INDESIT company

INC310GAID

INC310GAIS

52220a0 Exploded views

0522067: SEALS FOR DOORS FOAMED AS ONE PIECE

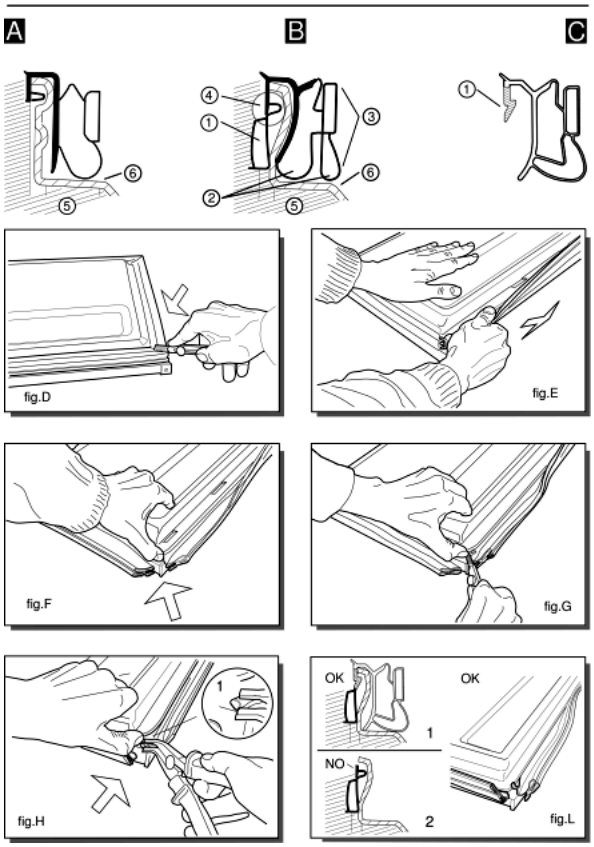
Various types of gaskets with different profile, as shown in figures (A) and (B), are used to fix the door (fig. A-5; B-5) and the inner door (fig. A-6; B-6) on the block foamed doors of combined freezers and refrigerators.
---Ilpea profile 245; 179; 412 (fig.A)
---Ilpea profile 287 (fig.B)
When replacing gaskets with profiles 245; 179; 412 these are fixed with screws (2 per corner) to the door.
Gaskets with profile 287 can not be used as spare parts but are designed to house the Ilpea type 900 gaskets (see figure C).
When replacing the gasket (287), once it is removed you will find a pocket (fig. B-1) between the door and inner door.
The rigid tooth (fig.C-1) of the gasket (900) is inserted inside between the pocket and the inner door, doing away with the need for screws.
Gasket with profile 287 is easy to identify since it has an exterior double edge (fig.B-2) which acts as a cushion when the door is closed.

To replace this gasket, follow these steps:
---Dismount the door and cut the four corners of the gasket along the joint (fig.D);
---lift the gasket and pull it carefully along its full length without tearing it (fig.E).
The purpose here is to detach the inner door slightly from the foam along the exterior edge for a depth equal to that of the gasket (fig.B-3);
---lift the corner of the inner door slightly, prising it up with your thumb (fig.F). Do not use a tool which might break the inner door;
---continue cutting the gasket inside the inner door for about 6 mm (fig.G);
---push in the tip of the pliers (type USAG N131) and pull outwards until you see the top edge of the pocket (fig. B-4) which is empty (fig.H-1);
---if you carry out this operation correctly (fig.L) you will be able to pull off the top edge of the pocket for the full length of the door.
If the gasket tears before the top edge (fig. L-2) you should repeat this operation from the other corner of the door.

---once the gasket (287), has been removed the space above the pocket (fig. L-1) can house the rigid tooth (fig. C-1) of the gasket 900.
When you fit this gasket ensure that it lies flush against the edge for the full length of the door.
If the rigid tooth is difficult to fit, eliminate any residues of foam between the door and the inner door in the gasket area.
fig.5131549A

n1030091: New control moulding on built-in mechanical 310 litre Indesit fridge-freezers

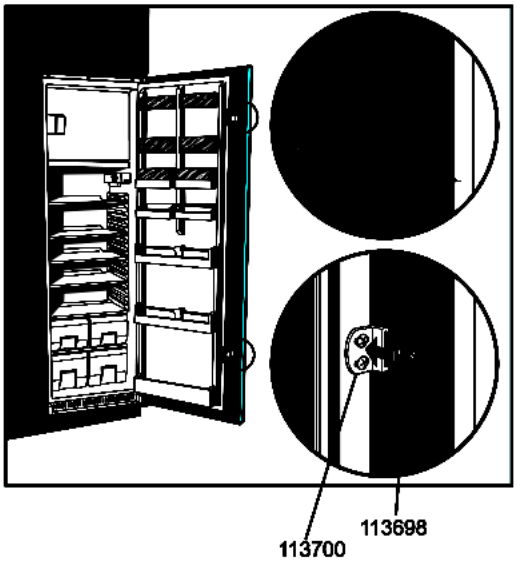
In June 2005 (serial no. 50606.0001) the Carinaro factory modified the control moulding on built-in 310 litre Indesit fridge-freezers (mechanical), unifying it with that of the electronic version in fixing and eliminating the control support.
The new moulding cannot be fitted on premodification models because also the control box and thermostat knob have been modified.
The moulding is fixed with two screws that are accessed by removing the hole covers.

New parts

118930 - CONTROL MOULDING LXHXD 328X60X22 (1-HOLE) INDESIT
099226 - THERMOSTAT KNOB WHITE
088521 - CAP RH WHITE
088522 - CAP LH WHITE

Parts replaced

082176 - CONTROL MOULDING LXHXD 328X60X21 (1-HOLE) INDESIT
064626 - THERMOSTAT KNOB WHITE
064613 - CONTROL SUPPORT LXH 328X56X10
